## Department of Transportation

**MEMORANDUM**

**SUBJECT:** ZC Case No. 14-12E – 1329 5<sup>th</sup> Street NE Stage 2 PUD

Figure 1 Site Plan (Source: Applicant's Supplemental Statement)

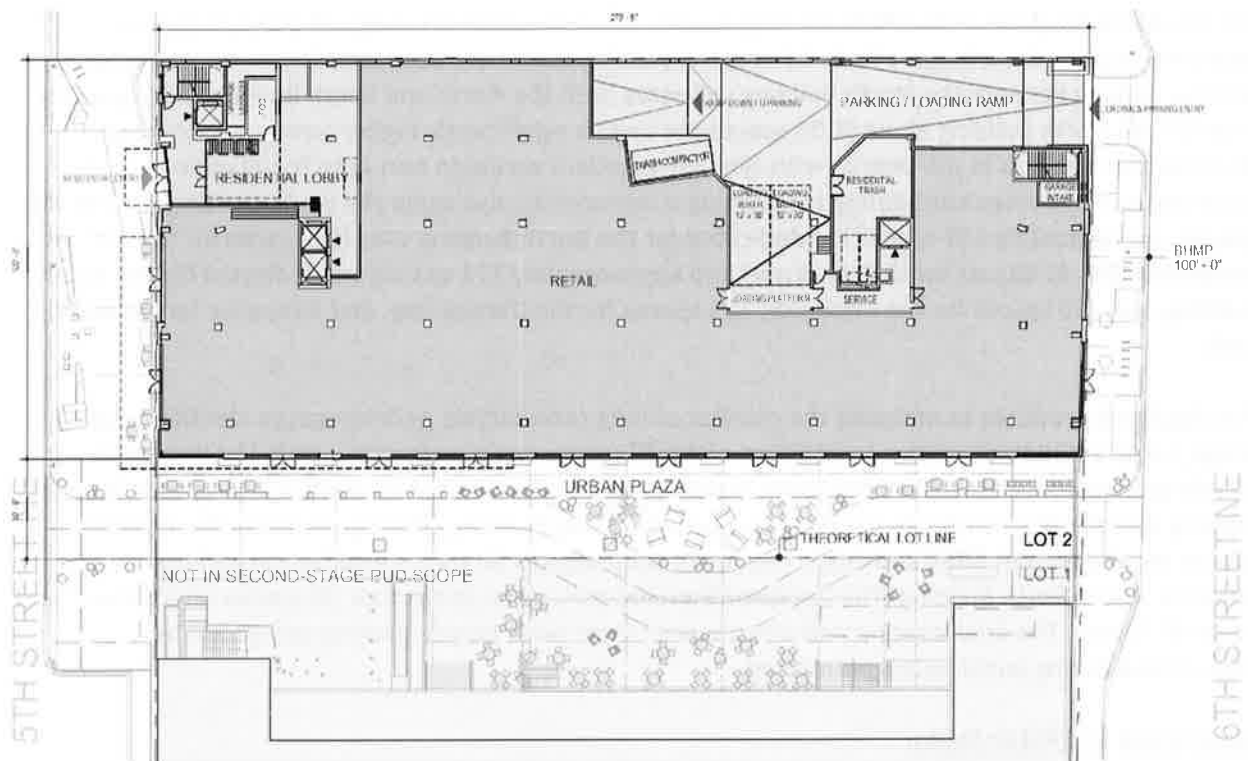
Consistent with the Stage 1 PUD approval, parking garage, loading, and trash access will be provided from a curb cut on 6<sup>th</sup> Street NE. The curb cut location has been shifted six (6) feet south of the property line in order to meet DDOT standards for driveway offsets from an adjacent parcel. Access to the two (2) 30-foot loading berths and one (1) 20-foot service delivery space is proposed via the curb cut. All truck maneuvers will be accommodated with head-in/head-out maneuvers across public space consistent with DDOT standards. A site plan is shown in *Figure 1*.

The Applicant proposes knock-out panels along the north edge of the parking garage to facilitate access to the adjoining property, which was approved as a Stage 1 PUD (ZC Case No. 15-24/15-24A). The knock-out panels allow the adjacent property to provide access via 6<sup>th</sup> Street, thus preserving the option for 5<sup>th</sup> Street to fulfill a more pedestrian-focused character as envisioned in the Union Market Streetscape Guidelines. Such shared access could be utilized on a full time or temporary basis when 5<sup>th</sup> Street may be closed to vehicular traffic for special events. In order to realize the benefits of the knock-out panels, the Applicant is expected to commit to language that provides the adjacent property owner with permission to utilize the knock-out panels to access the North Building's garage and driveway access to 6<sup>th</sup> Street NE. Additionally, the Applicant is expected to provide a letter of acknowledgement from the adjacent property owner to the north confirming awareness of the knock-out panels. DDOT will work with the Applicant for ZC Case No. 15-24/15-24A through a future Stage 2 PUD process on a site access scheme that takes advantage of the knock-out panels.

Figure 2 Preliminary Streetscape Plans (Source: Applicant's Supplemental Statement)

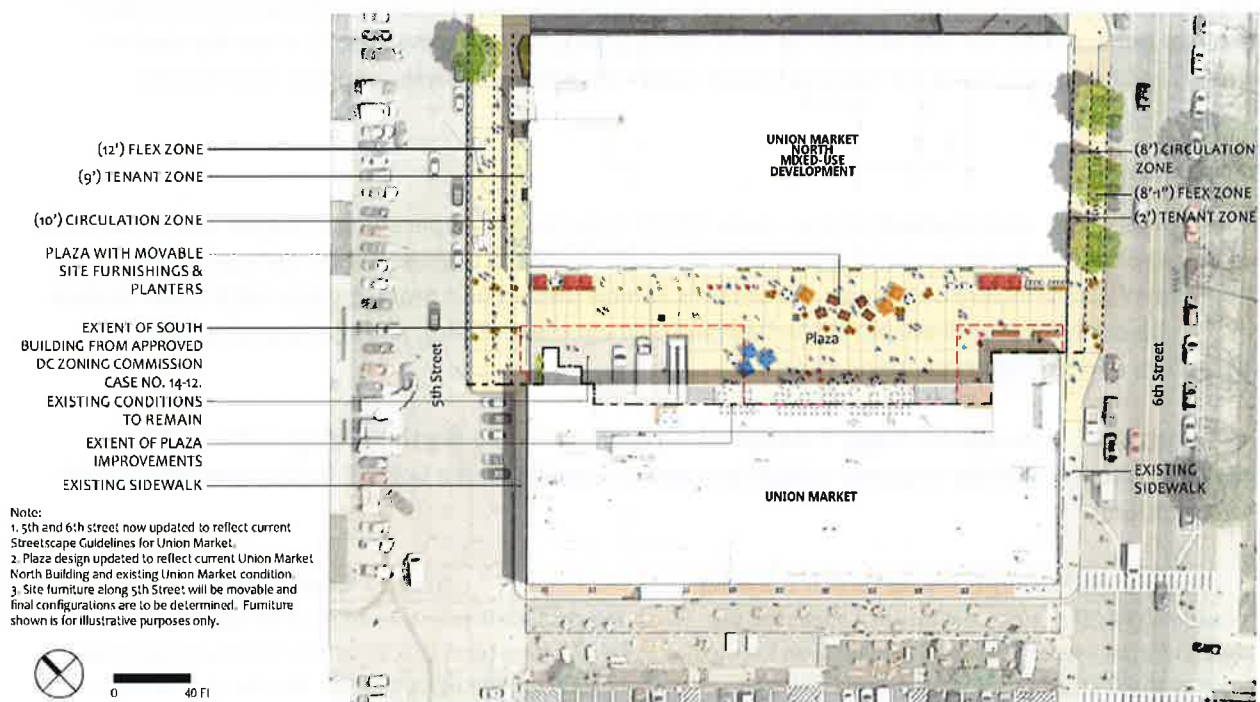
The Applicant proposes to improve the adjacent streetscape consistent with the Union Market Streetscape Guidelines. The Applicant will need to coordinate with DDOT to appropriately design the transition from the improved streetscape locations back into the existing conditions to the north and south of the North Building. Special attention is needed to ensure an ADA-compliant pedestrian path and adequate stormwater management facilities are provided. Of note, the Union Market Streetscape Guidelines call for non-standard treatments, including a curbless street section on 5<sup>th</sup> Street that requires a non-standard trench drain. The Applicant will be required to sign a maintenance agreement

as a condition of public space permit approval for any non-standard elements. In addition, coordination with DDOT and DC Water is needed on the 6<sup>th</sup> Street frontage to ensure the curblin and street trees are designed such that they meet the streetscape guidelines and minimize potential impacts to sensitive subsurface infrastructure. Preliminary streetscape plans are shown in *Figure 2*. Final design of the streetscape will be determined during the public space permitting process.

The Applicant proposes building projections on the 5<sup>th</sup> Street and 6<sup>th</sup> Street frontages. All building projections are expected to comply with the Construction Code. Oriel windows may project a maximum of four (4) feet into public space. Of note, the plans show a thick gray band that extends into public space and encircles the oriel window projections on 5<sup>th</sup> Street and 6<sup>th</sup> Street. This is not a type of projection specifically allowed by regulation and would likely require a modification from the Construction Code.
